Technical change to unshielded K- and L-coded and shielded T-coded M12 power cord sets

The overmolded unshielded K- and L-coded and shielded T-coded M12 power cord sets will be changed after a transitional period.
Please pass on this Product Change Notification (PCN) to your employees and, if applicable, to your customers.

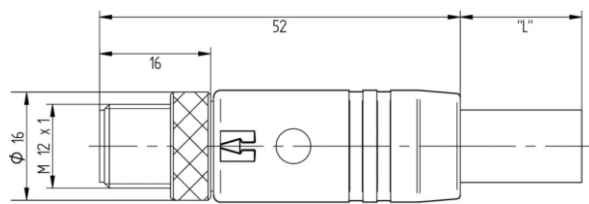
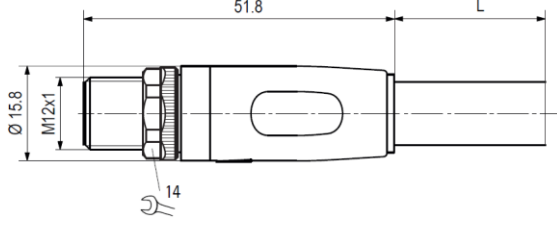
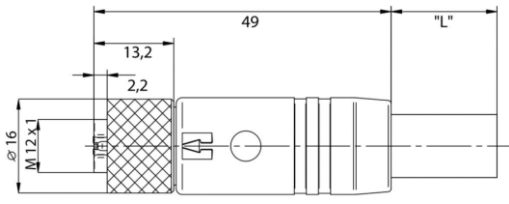
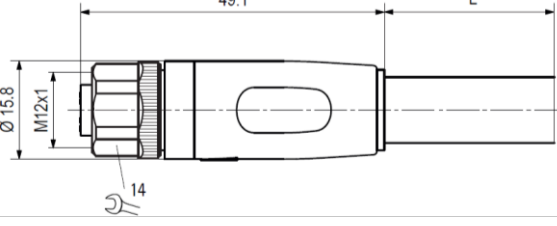
As part of the standardization of the portfolio, the connector design for the unshielded K- and L-coded and shielded T-coded M12 power cables will be changed. The dimensions of the straight versions will remain the same, while the angle of the cable outlet on the angled versions will be slightly increased to simplify installation during production. All other technical specifications will remain the same. Existing approvals are not affected by the change and will remain valid.
